stm32-blinky — Design Document

PCB-0001-A

Board review: stm32-blinky (P8 adversarial pass)

al-ee		
Sheet: /		
File: stm32-blinky.kicad_sch		
Title: stm32-blinky: STM32F103C8T6 blinky board		
Size: A3	Date: 2026-07-27	Rev: 1
KiCad E.D.A. 10.0.3		Id: 1/1

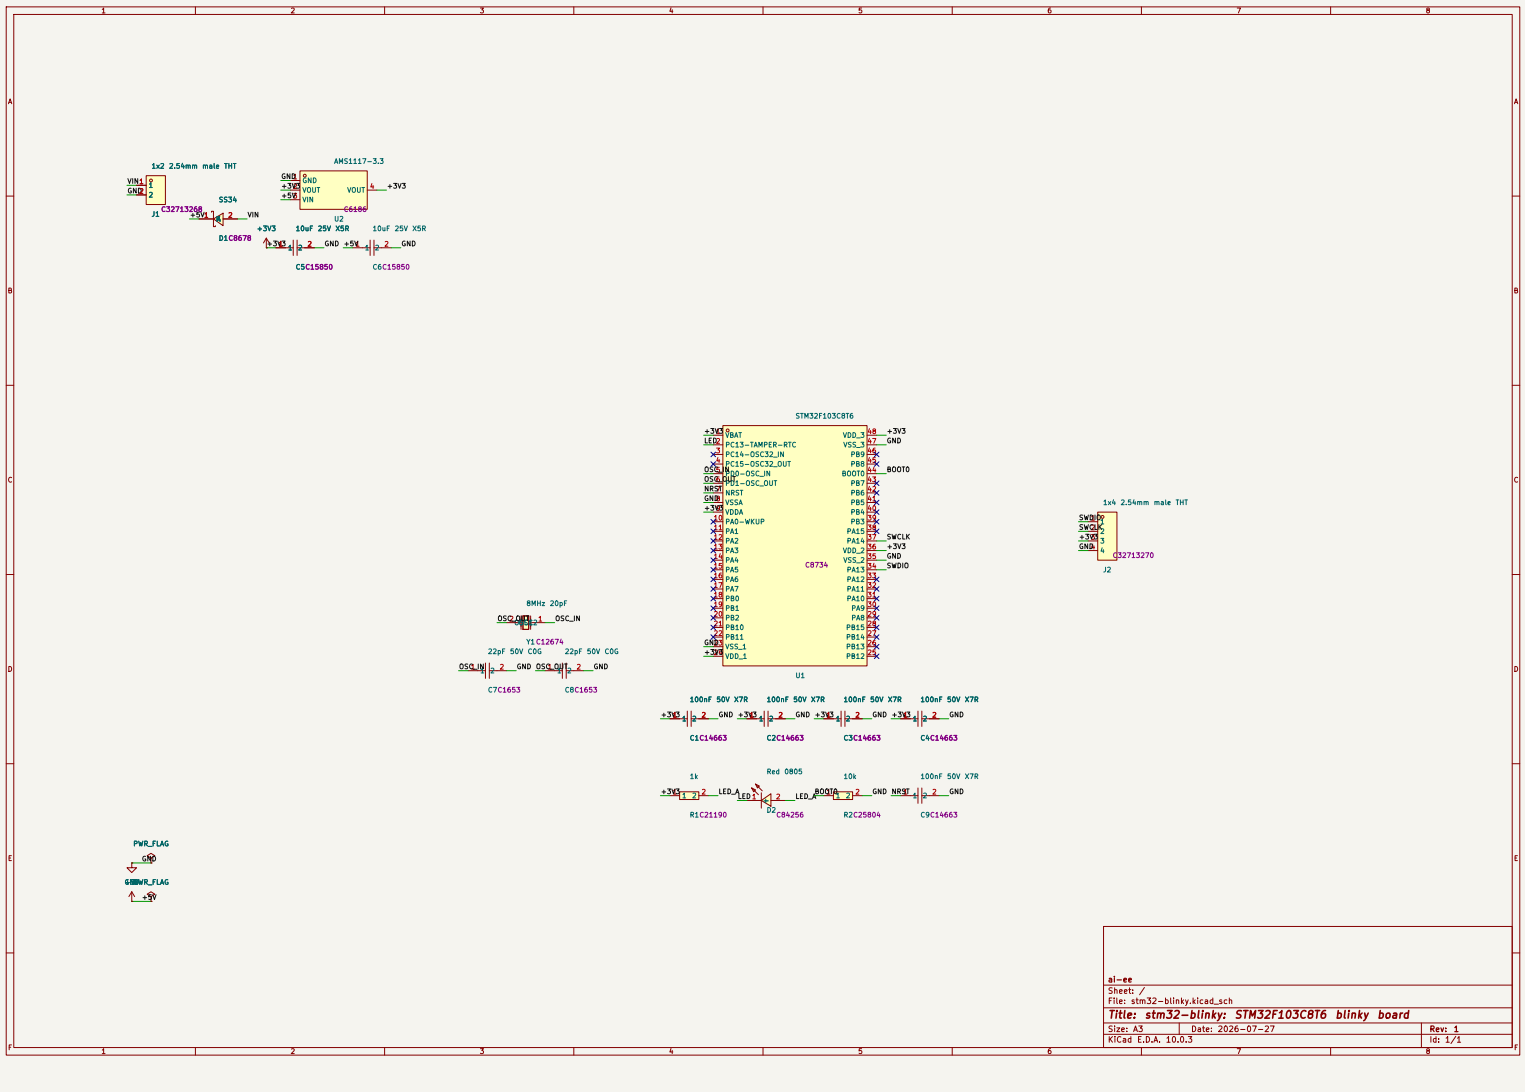
W1 (reviewer warning 4, issue 4): "erc-pintypes-vacuous" - easyeda2kicad symbols carry mostly-passive pin types even after datasheet-driven retyping of supplies, so ERC's driver-conflict/float checks have reduced power on this board. Waived: connectivity was independently hand-verified by the adversarial reviewer against both datasheet extracts (all 9 supply pins, polarity, strapping). Tooling fix (retype at lib_pull time, GPIOs as bidirectional) queued as S14 hardening item.

Note: reviewer warnings 2 (VDDA 1uF//10nF) and 3 (VDD_3 bulk) were FIXED, not waived, along with error 1 (22uF tantalum LDO output cap) - see state.json issues 1-3 and the second erc gate commit.

`reports/renders/stm32-blinky_top.png`

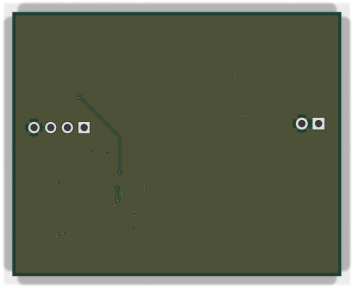
ERROR 1 - J1 power input has no polarity legend on silk (requirements miss)

requirements.md sec 2 and architecture/blocks.md both promise the 5 V input "polarity marked on silkscreen" (J1 pin 1 = +5 V, pin 2 = GND). The as-built board has NO text or +/- legend anywhere: silk carries refdes only (there is not a single gr_text on the board). What exists at J1 is a pin-1 dot and a square pad (see crop_j1_d1.png) - and the dot sits on the header body outline,

so after the header is soldered the plastic covers it. Post assembly the top side shows nothing but "J1"; the square pad is visible only from the bottom.

Consequence: the unkeyed 2-pin input can be plugged backwards with no on-board hint. D1 (series SS34) prevents damage - reversed input just does not conduct - but the user gets a dead board and no way to know why or which way is right without opening the design files. This is the board's primary human interface and an explicit requirements promise. Fix is two silk texts ("5V", "GND" or "+", "-") next to the holes, outside the header body. Must fix before fab; there is ample empty silk area (left region is empty).

WARNING 1 - J2 SWD pins unlabeled (architecture promise miss)

`blocks.md` promises "Canonical pin order (silk-labeled): 1 = SWDIO, 2 = SWCLK, 3 = 3V3, 4 = GND". Electrical order verified correct from the netlist (pads: SWDIO/SWCLK/+3V3/GND, U1 PA13/PA14 to pins 1/2). But there are no labels - only a pin-1 square cell (`crop_d2_j2.png`) which the header body covers after assembly. ST-Link clones are wired pin-by-pin; swapping 3V3/GND shorts the debugger's 3.3 V rail to ground. Same trivial fix as ERROR 1 (four small silk texts below the header row - the area under J2 is clear). Strongly recommend fixing together with ERROR 1; warning rather than error only because requirements.md itself demands the ORDER (met), the labels are an architecture-level promise.

WARNING 2 - refdes association ambiguity (cap cluster + C3-under-J2)

Confirmed the P6-flagged issue on `crop_u1_cluster.png` and `crop_d2_j2.png`; judged as follows:

- "C11" text sits directly above R1's body; "C1" text below-left of R1; "C7"/"C8" labels float between parts they do not touch. Among these 0603s are four DIFFERENT cap values (22 pF, 10 nF, 100 nF, 1 uF) plus a 1 k resistor - a hand-rework or debug probe guided by silk has a real chance of landing on the wrong part.
- "C3" text renders directly under J2 pads 3-4 and reads like a header label (its own body is 3.6 mm away). Mildly reinforces the J2 labeling problem: someone may read "C3" while counting SWD pins.

Assembly itself is CPL-driven, so production risk is nil; consequence is limited to bench rework/debug confusion. WAIVER RECOMMENDED for rev A - but since ERROR 1 forces a silk edit session anyway, nudging these labels onto their parts at the same time costs minutes.

NOT waivable in this reviewer's judgment: ERROR 1 (J1 polarity legend) - explicit requirements promise, primary user interface, zero-cost fix.

`reports/renders/stm32-blinky_bottom.png`

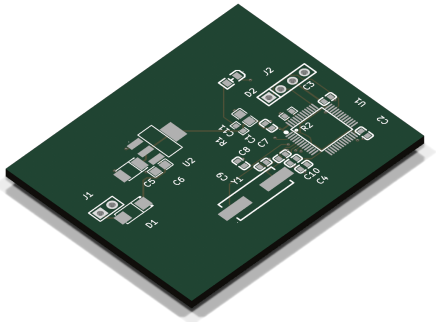
- Connector reality: J1 3.5 mm from the left edge, J2 within 3.3 mm of the right edge, both vertical THT male headers with open space around and below - hand-solder access trivial (bottom face is bare pour, `stm32-blinky_bottom.png`), jumper access unobstructed, no tall parts anywhere near. Board is enclosureless by requirement, so no reach issues.

- Bottom copper: near-solid GND pour, exactly one ~12 mm diagonal signal excursion plus one stub in the J2/D2 quadrant - nowhere near the oscillator or the LDO loop; stitching vias distributed. Clean.

`reports/renders/stm32-blinky_iso.png`

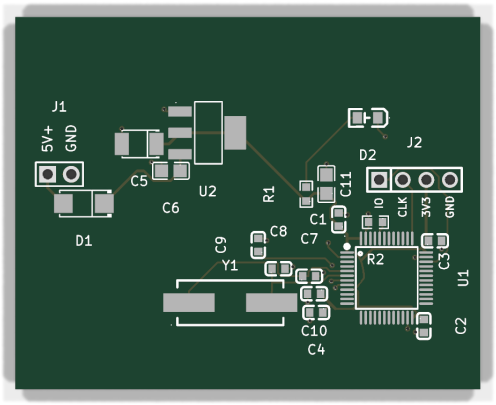
- No 3D models render in the iso view (bare footprints), so assembled-body absurdities (header plastic orientation, crystal can height vs nothing) could not be visually confirmed; at this part mix the residual risk is negligible.
- fp_verify overlay reports exist for 6 footprints but were skipped for D1 (SS34/SMA) and Y1 (HC-49S). Mitigated here by manual geometry decode (D1 band-vs-net correct; Y1 pad span LS 12.7 matches HC-49S-SMD), but the physical-part-vs-footprint pad-1 convention for D1 rests on the LCSC footprint being band-on-pad-1, which lib_pull pulled but no overlay confirmed.
